## Appendix - Sunnica Arb comments

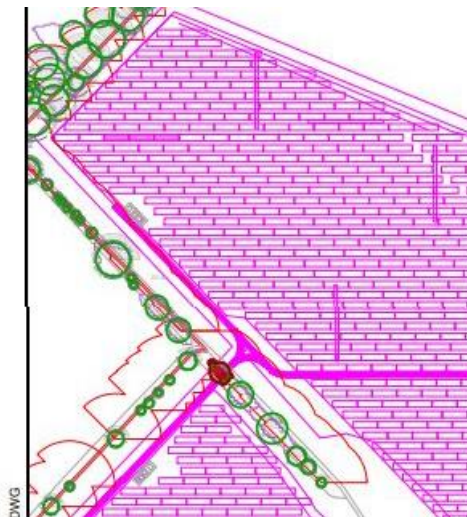
Map 6 page 148 and the tree schedule page 125 show three TPO trees to be removed from the TPO on Chippenham Road not the two described as above which is correct?
